# STANTON WILLIAMS

**Introduction**

In January 2009, Argent and Stanton Williams presented to the London Borough of Camden and English Heritage a proposal to modify the approved design of the Northern Elevation of the Eastern Transit Shed.

Proposed North Elevation to Eastern Transit Shed - Preliminary sketch image

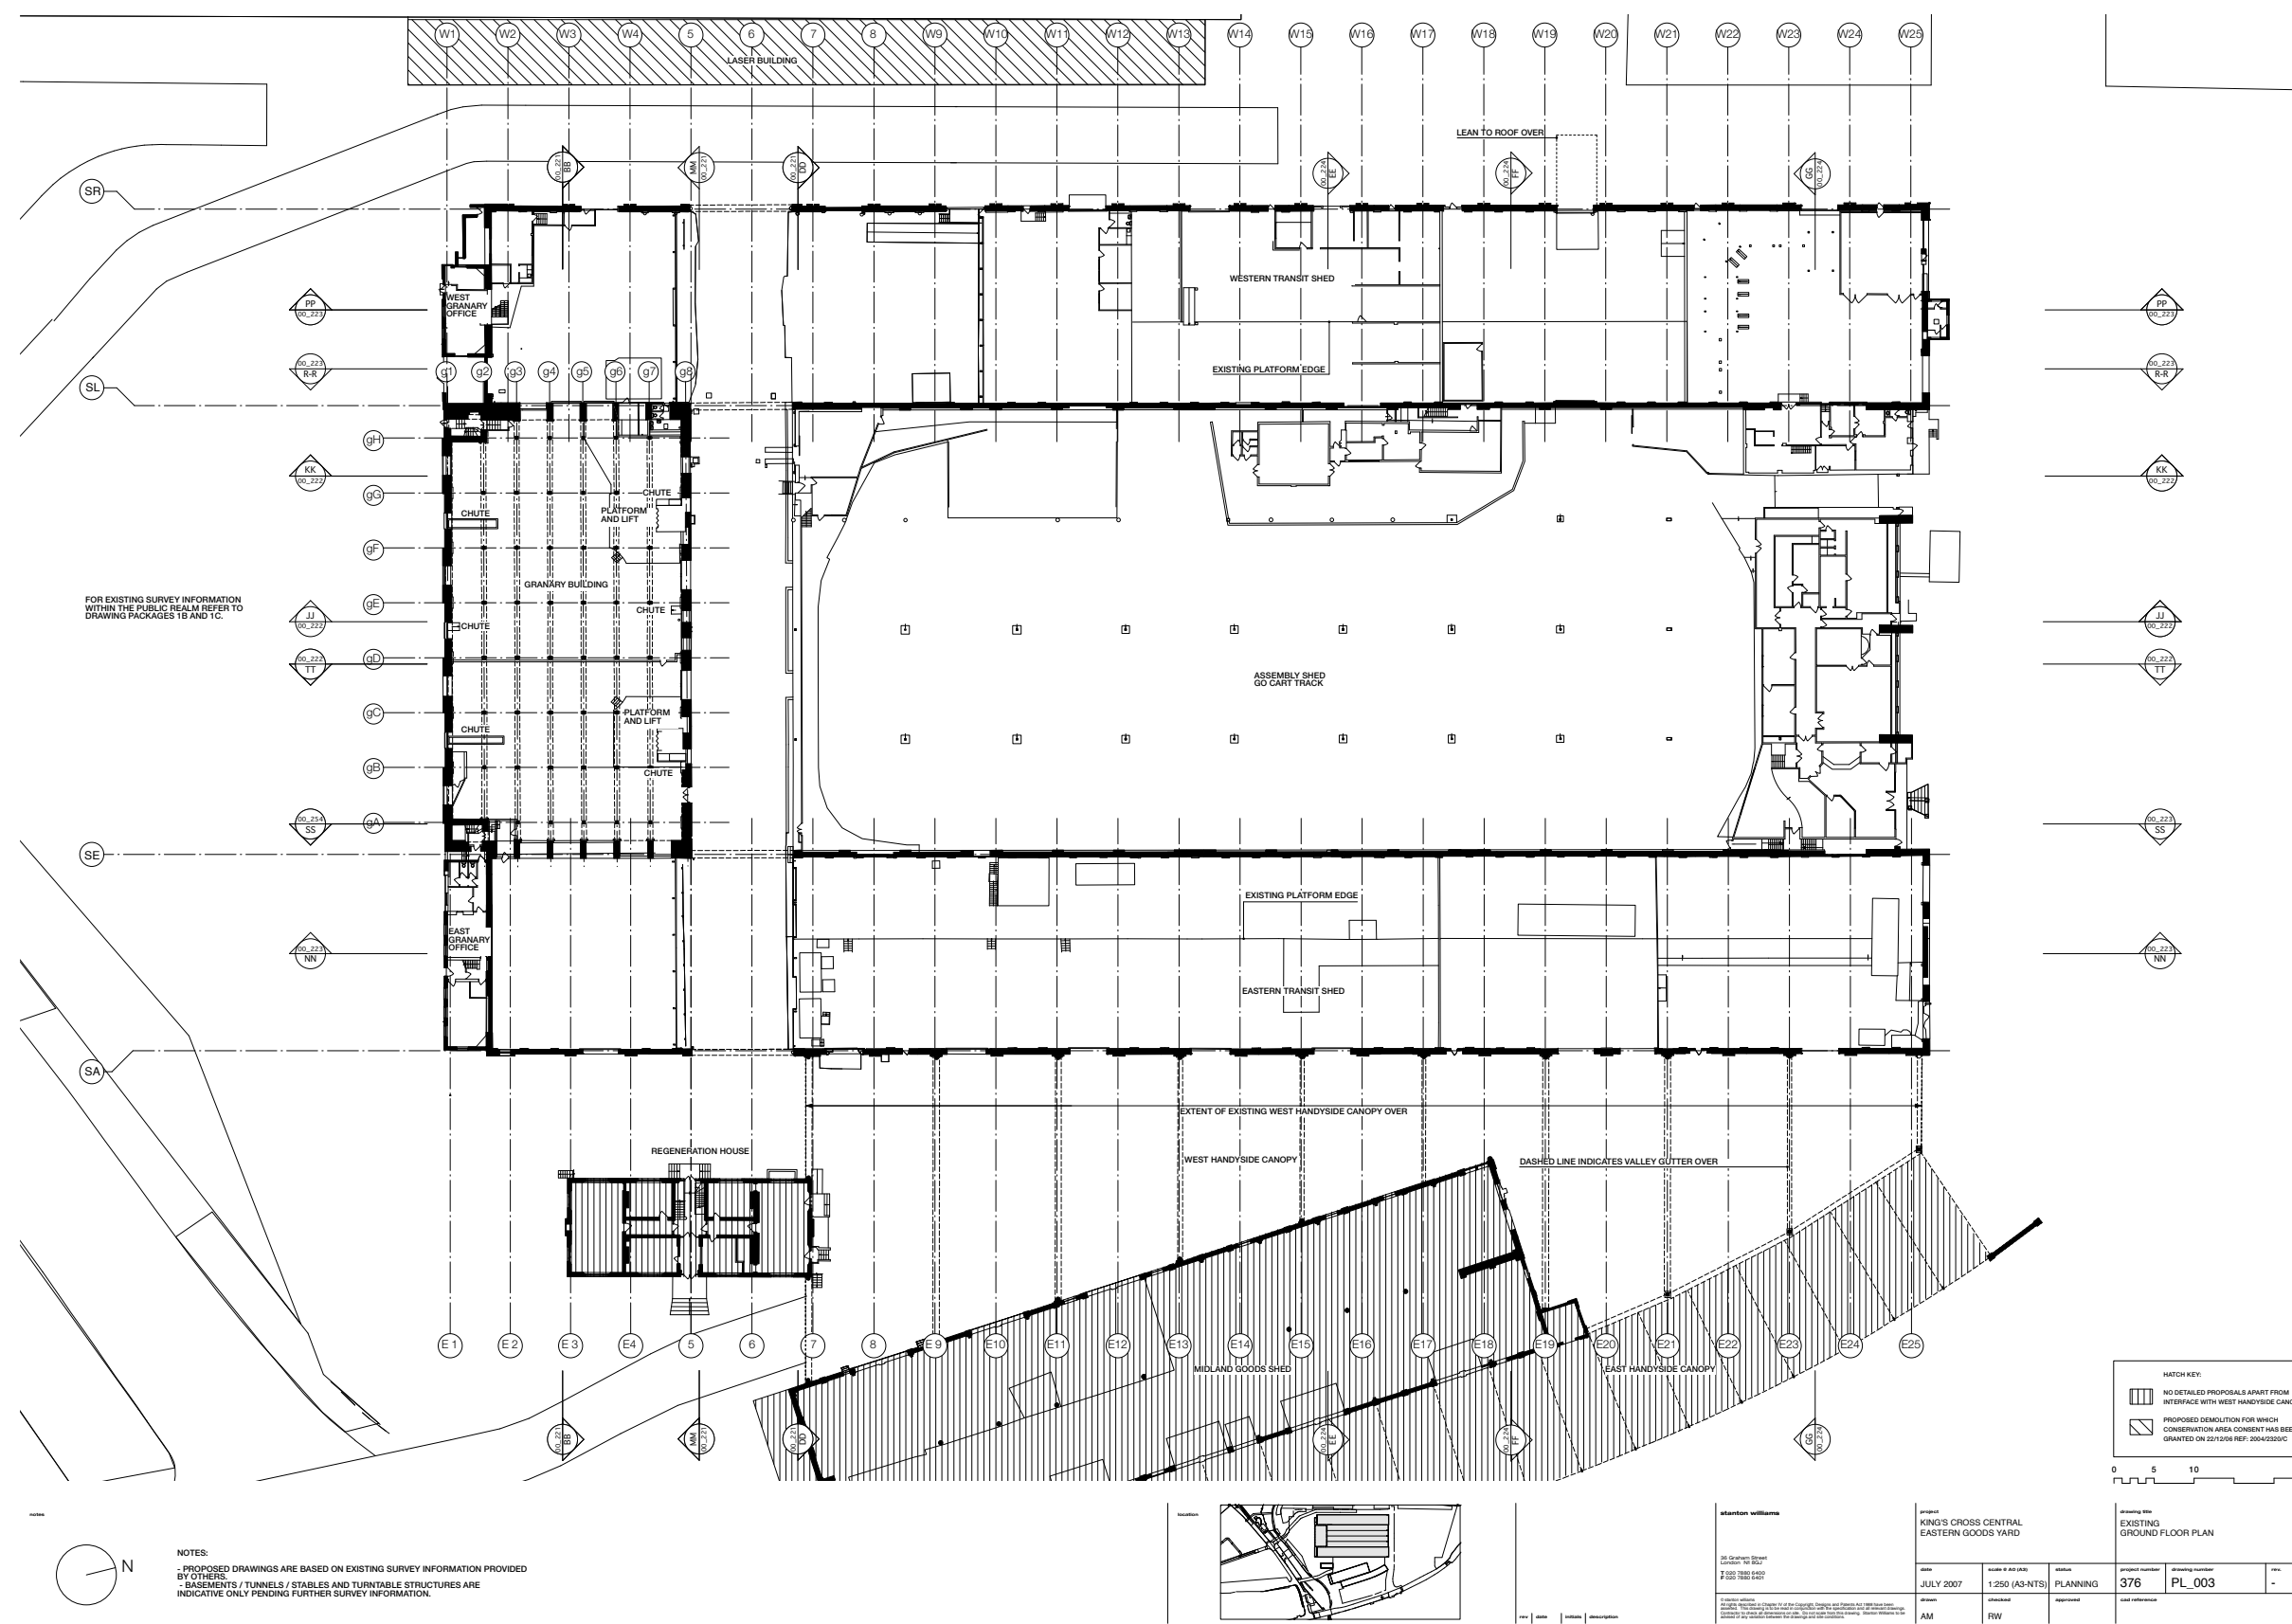
The new proposal, set out in the image below and the submitted drawings, seeks to retain much of the historical scarring from the building’s evolution. The two side arches will be reformed as per the existing Reserved Matters approval 2007/5228/P and Listed Building consent 2007/5230/L, locating the glazing on the inner wall face to reveal the wall depth and to suggest that these were originally open and not blind arches.

In a change to the approved scheme, the larger blind brickwork arch will now be mostly retained, along with remnants of the fireplace, chimney flues, a new smaller vertical, glazed opening will be inserted. In contrast to the two side arches, the proposed double glazed unit will sit flush with the exterior brickwork face, with complimentary detailing to maintain the same architectural language as elsewhere on the building. A metal acoustic separation panel will sit within the window recess, between the glazing and the first floor concrete slab.

The uses behind this elevation include various theatre preparation areas, changing areas and green room for the University of the Arts performing arts centre, where a high level of public view is not always desired. The proposed amount of glazing therefore provides greater privacy for these uses.

It is considered that the proposed changes to the central arch glazing will respond better to the geometry and the historic grain of the elevation, whilst maintaining appropriate daylighting for the uses inside.

NORTHERN ELEVATION OF EASTERN TRANSIT SHED  
RICHARD GRIFFITHS SURVEY 01:  
PROPOSED FACADE REPAIR (OUTSIDE OF CENTRAL ARCH)

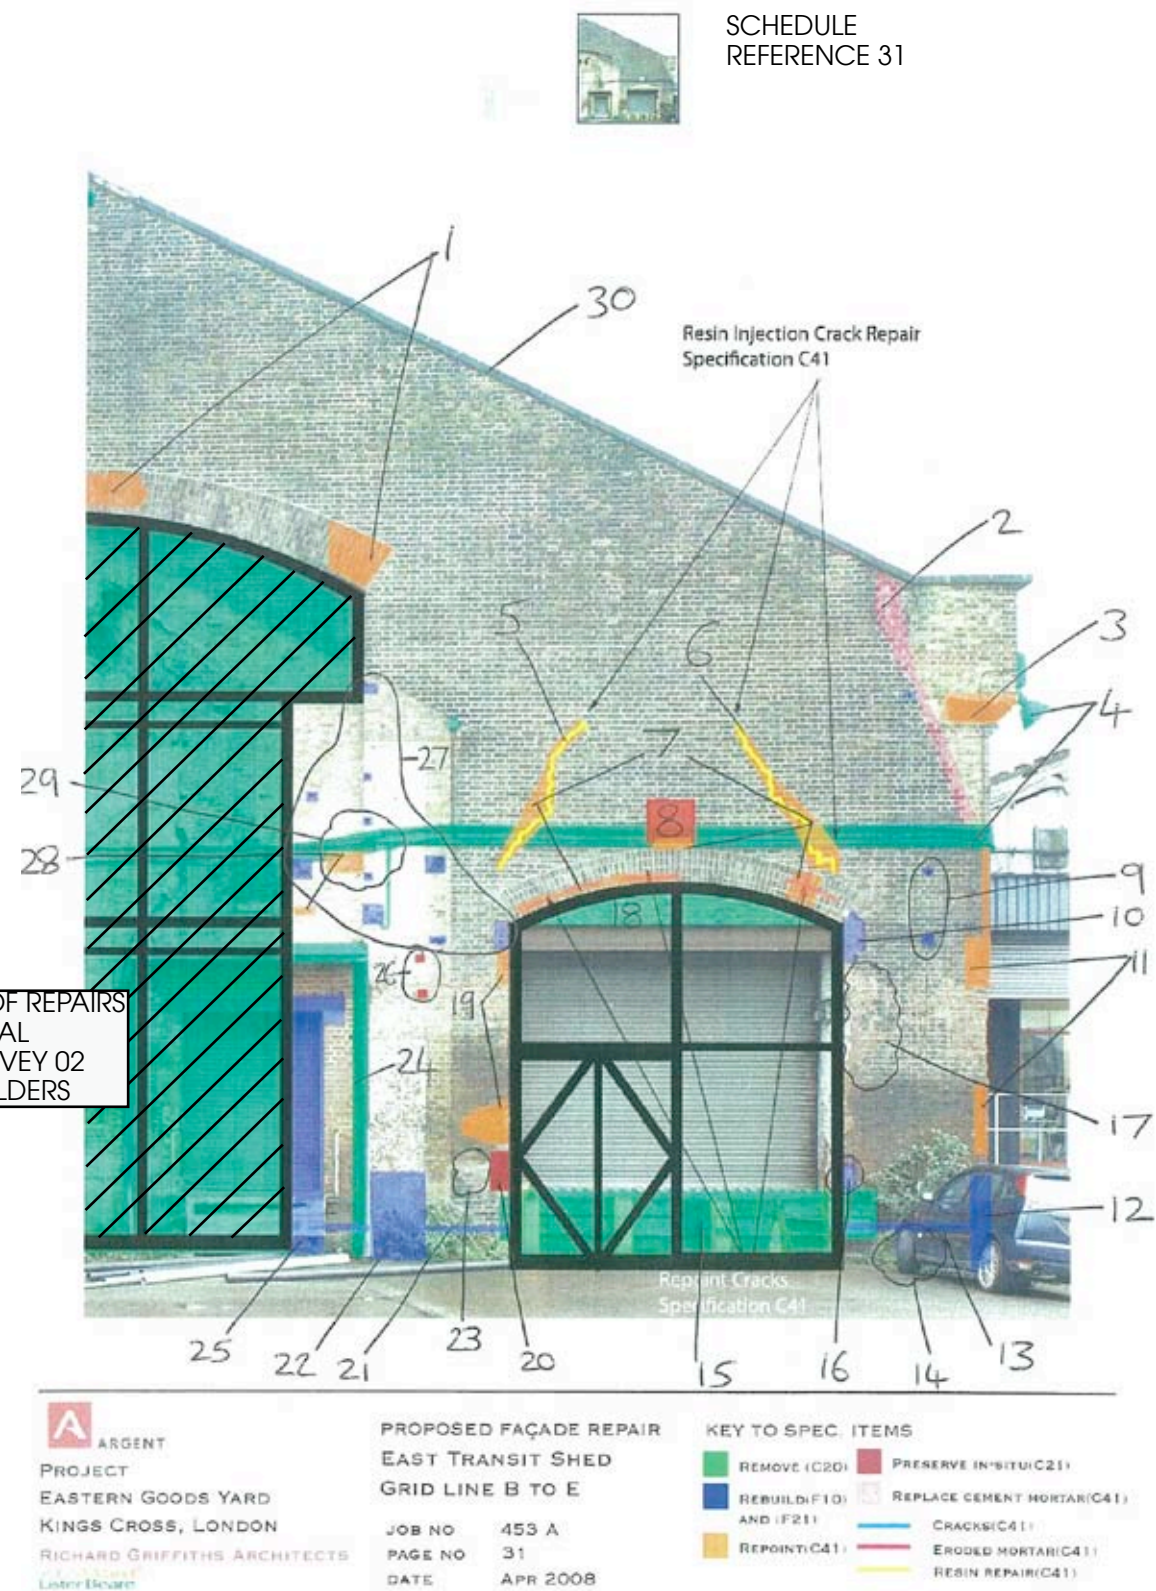
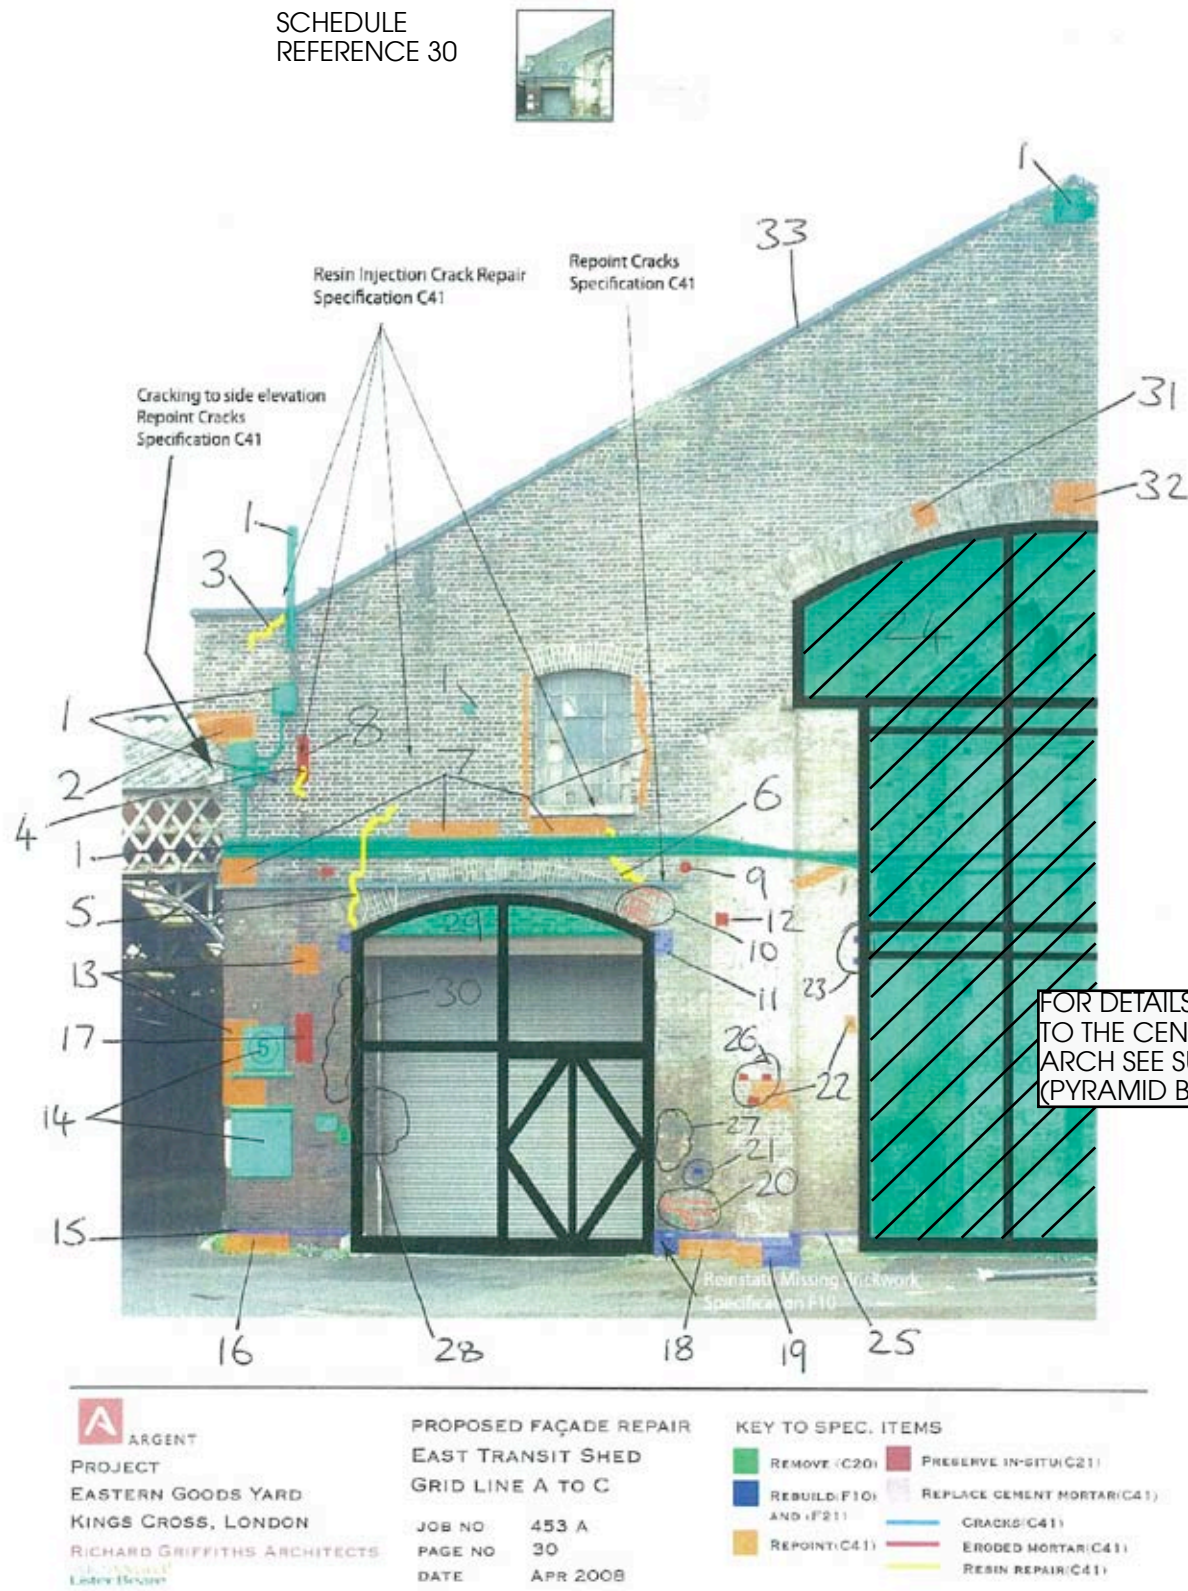
Appendix D includes drawings which detail the proposed areas of repointing and repair work to be completed on the northern façade of the Eastern Transit Shed. Survey 1 with associated schedule by Richard Griffiths Architects shows the repair work proposed outside of the existing central blind arch. Works to the area within the central arch, which includes the brickwork previously to be removed under the original Reserved Matters approval and Listed Building Consent, is shown in a separate drawing (Survey 2) by Pyramid Builders Ltd. Principally the works will involve repairs to and repointing of existing brick features and ‘scars’ on the façade to ensure that the façade is safe and structurally sound.

Ref		Location	Condition	Remedy	Remedial Ref	Quant		Notes
30	1	Mid-high level generally	Redundant electrical fittings and fixtures including cables	Remove and make good	C20	Item		
30	2	High level stone corbel to north east corner	Damaged and eroded stone work	Repair and make good	F21	Item		By others
30	3	High level to east side of gable	Stepped brickwork crack	Repair crack.	C41	1	m	
30	4	Mid level to east side of gable	Stepped brickwork crack	Repair crack.	C41	0.5	m	
30	5	Mid level extending upwards from east end of spring arch	Stepped brickwork crack	Repair crack.	C41	3	m	
30	6	Mid level extending upwards from west side of spring arch	Stepped brickwork crack	Repair crack.	C41	1	m	
30	7	Mid level brickwork generally	Eroded mortar pointing.	Rake out and repair	C41	7	m2	
30	8	High level to west of stone corbel	Historic fittings	Preserve in situ	C21	Item		
30	9	Mid level either side of spring arch	Historic fittings	Preserve in situ	C21	Item

30	10	Mid level to west side of spring arch	Eroded mortar pointing.	Rake out and repair	C41	0.5	m2	
30	11	Mid level to spring of arch either side	mismatched brickwork	Cut out and replace	F10, F21	20	no
